REVISION "A"

Ⓐ 5-10-99
SPLIT SIDE ROAD PHASING, ADD RT. SIGN, AND ADD LUMINAIRE.
SHA NO. XX100578S

MARYLAND DOT - STATE HIGHWAY ADMINISTRATION
Office of Traffic & Safety
TRAFFIC ENGINEERING DESIGN DIVISION
MD 108 AND TEN MILLS RD / CENTENNIAL PARK ENTRANCE

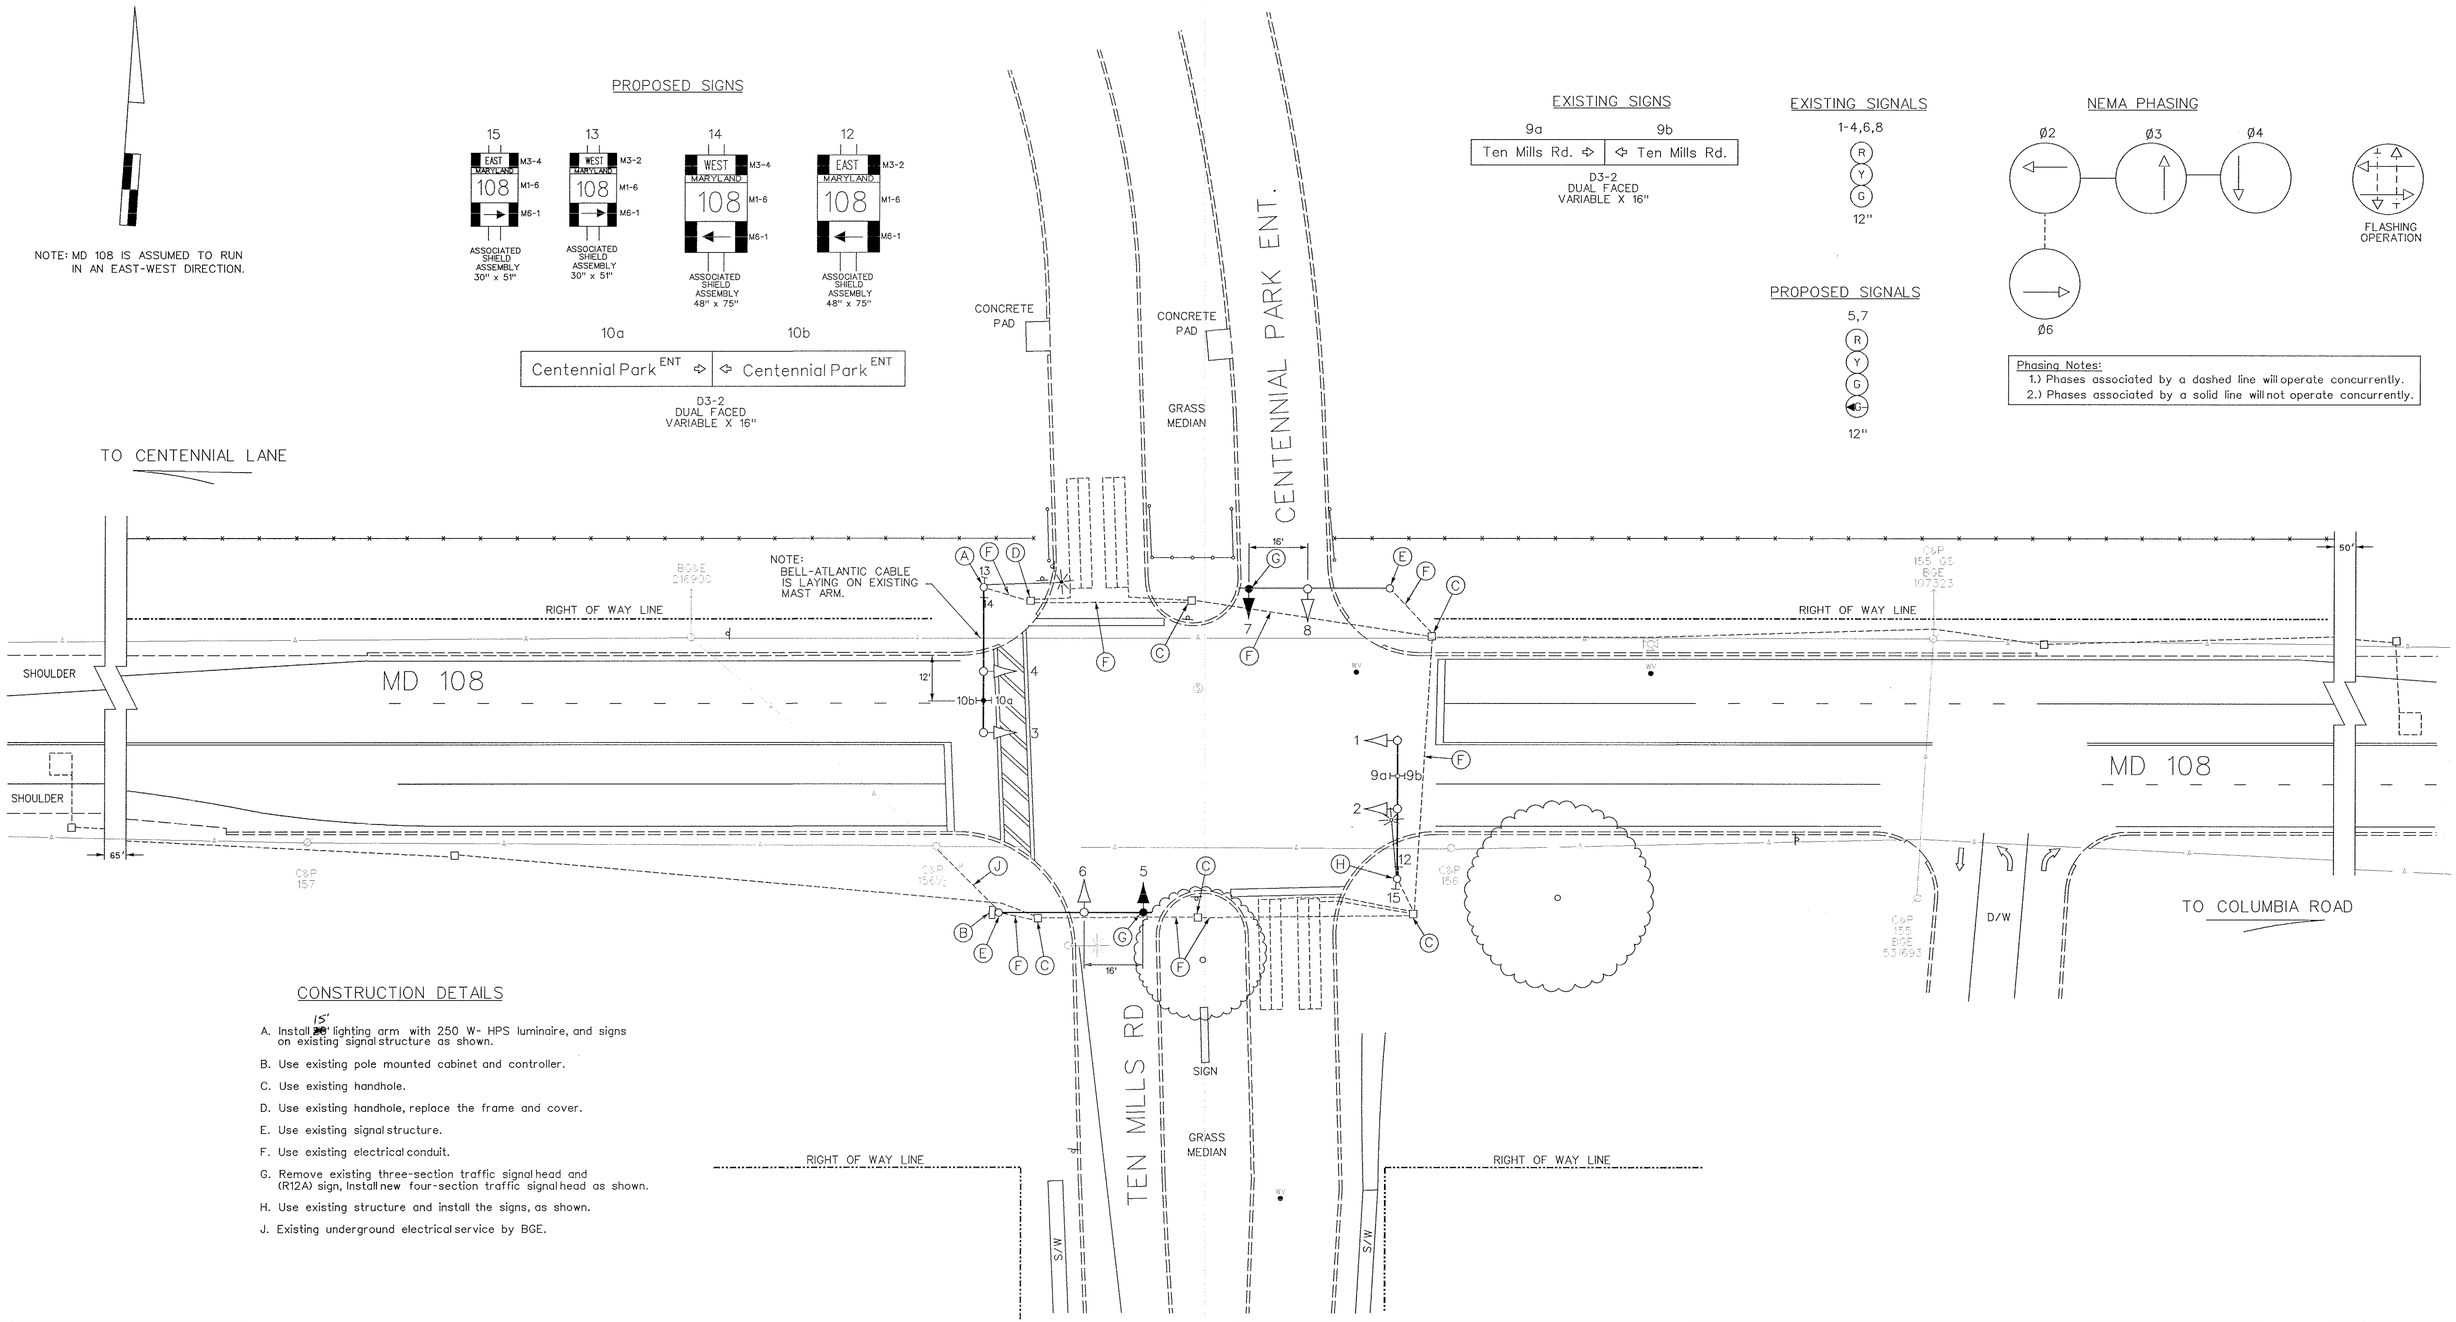
A. Install ~~20'~~ 15' lighting arm with 250 W- HPS luminaire, and signs on existing signal structure as shown.

G. Remove existing three-section traffic signal head and (R12A) sign, Install new four-section traffic signal head as shown.
